KARACHI MUNICIPALITY.

BUILDING SURVEYOR'S REPORT.

— PLAN SHOWING SANITARY CONVENIENCES —

— ON PLOT NO: 189 E-6 RAMSWAMY QUARTER. —

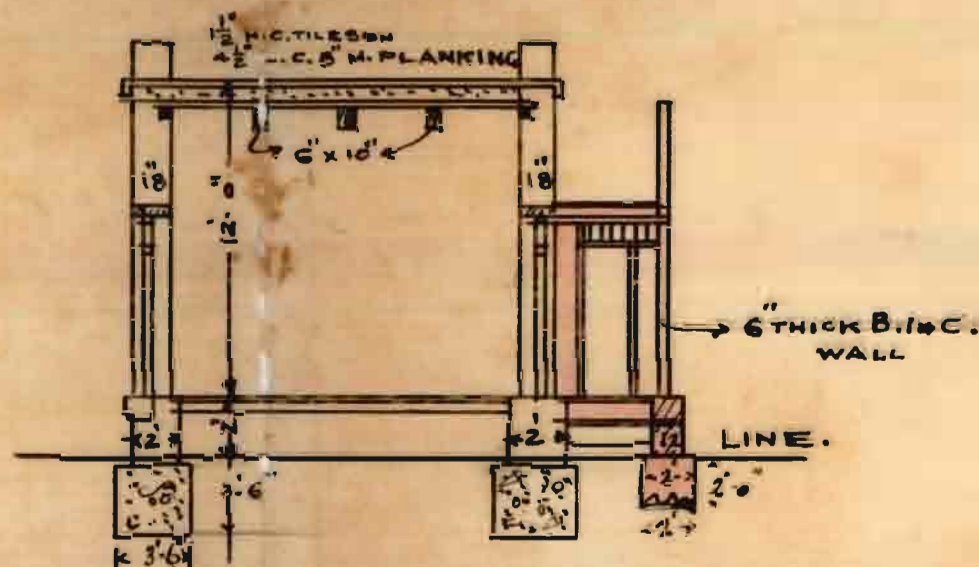
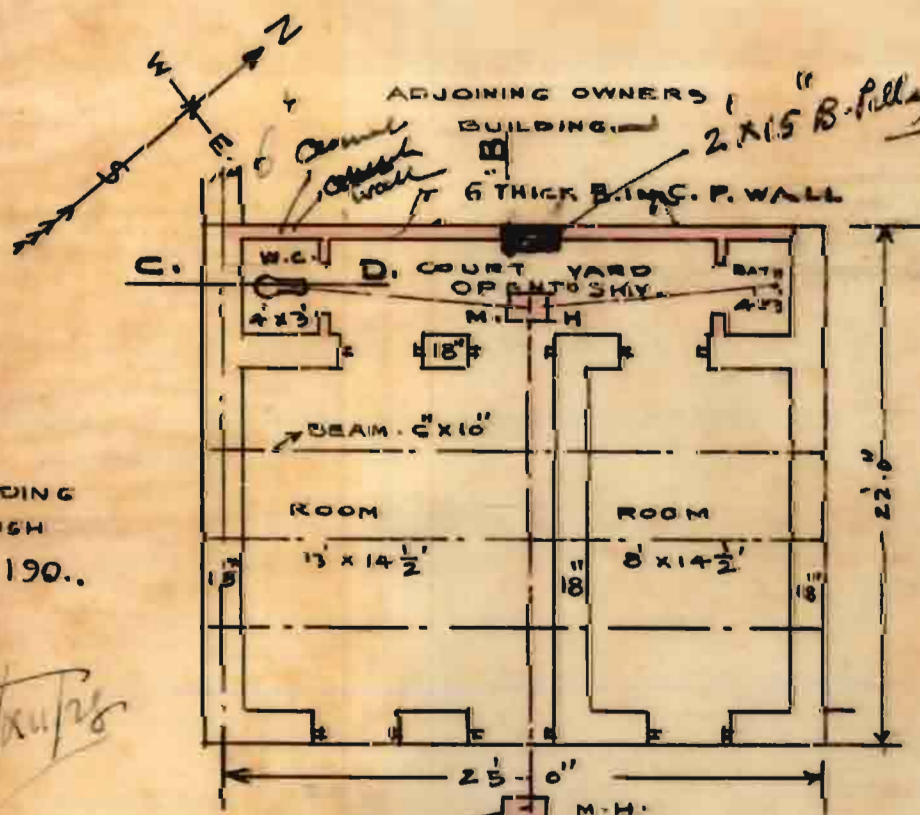
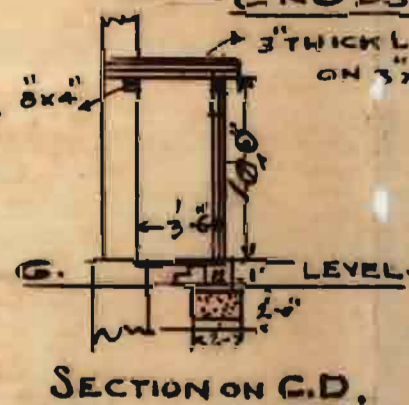
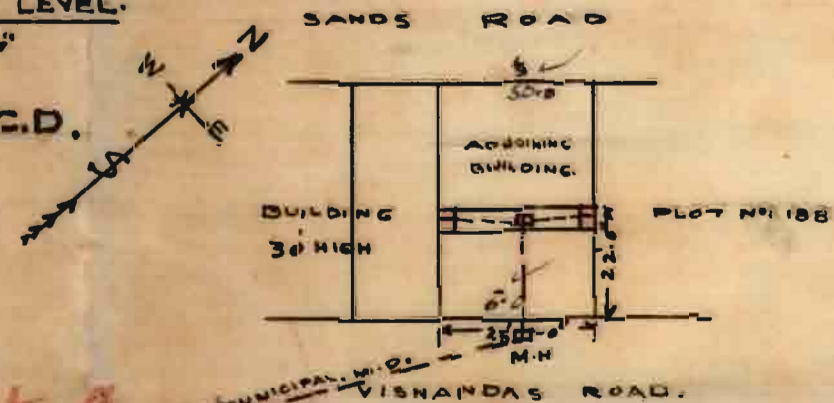
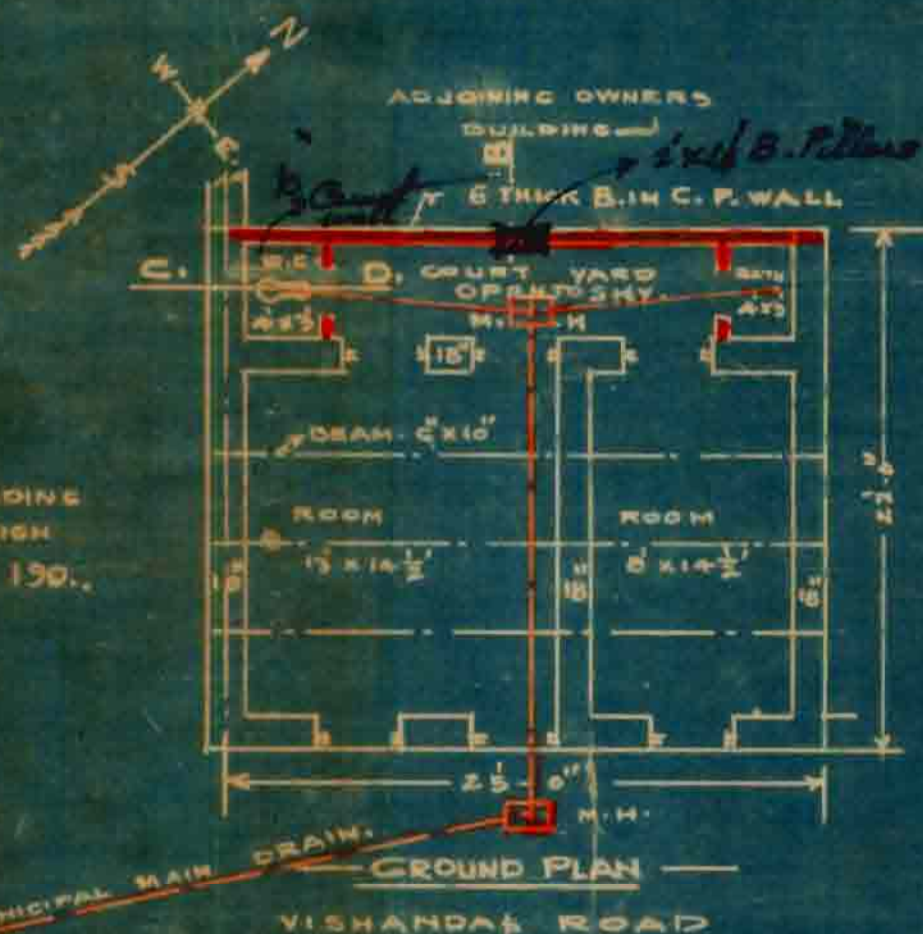
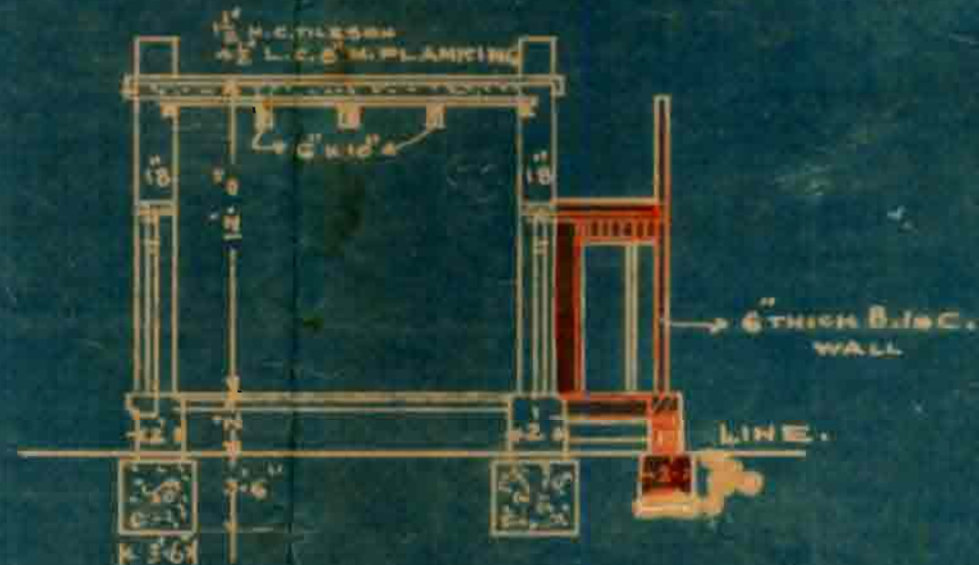
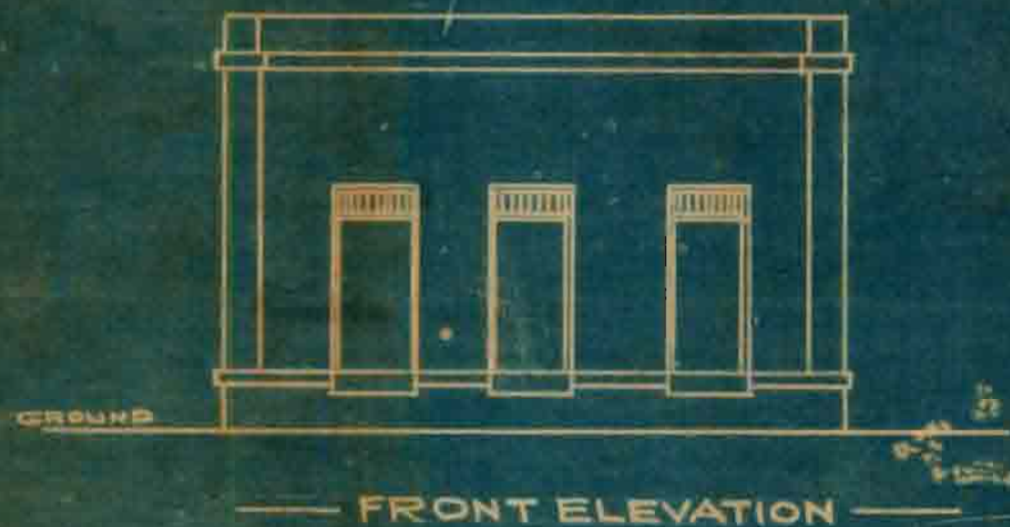
Please see remarks on Plan

The lat & W.C. should be 10 ft.

Pillar 2' x 15" to be provided.

The W.C. should be 6" cement plastered.

Plans may be approvedL.M.A.
6/12/28
